FLYSKY RC MODEL TECHNOLOGY CO., LTD

Ref: FCC Class II Permissive change for FCC ID: [N4ZST800](#)

This is to request a Class II Permissive change for FCC ID: [N4ZST800](#) originally granted on [02/13/2022](#) (date).

Original:	New:
FS-ST8/ST8/EX8	FS-ST8B/ST8B
 <p>ANT1</p> <p>ANT2</p>	 <p>ANT1</p> <p>ANT2</p>

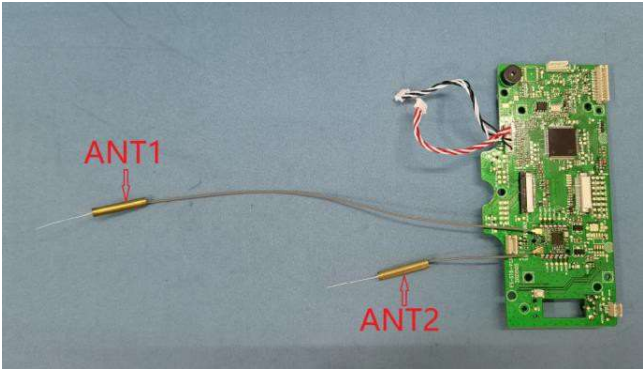
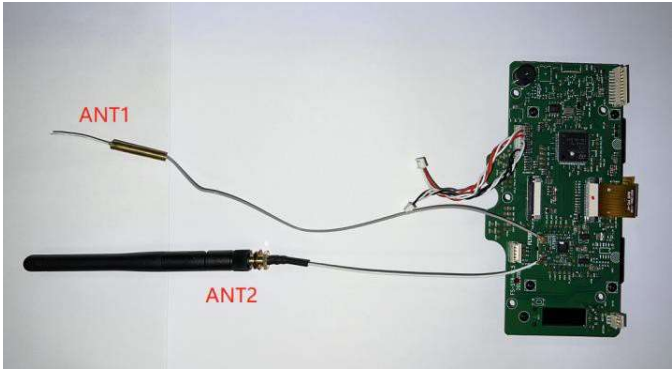
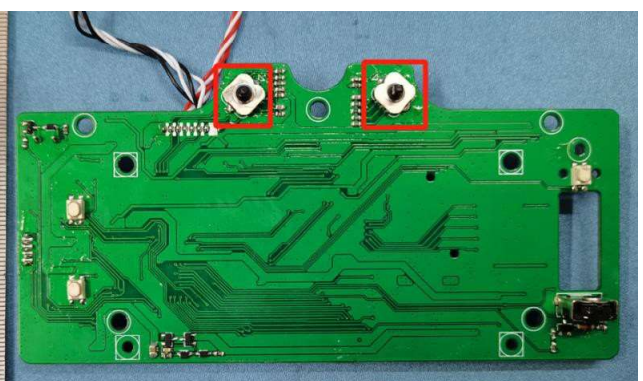
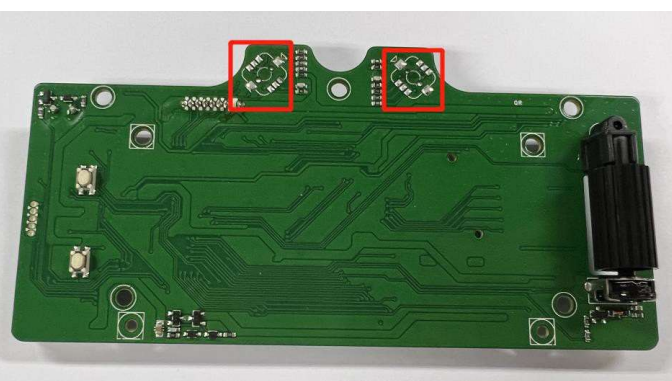
- 1、ANT2 changed the brass antenna to glue stick antenna: Better performance;
- 2、Delete two switches, and the other two add waterproof caps;
- 3、Delete two keys.
- 4、Delete serial model number.
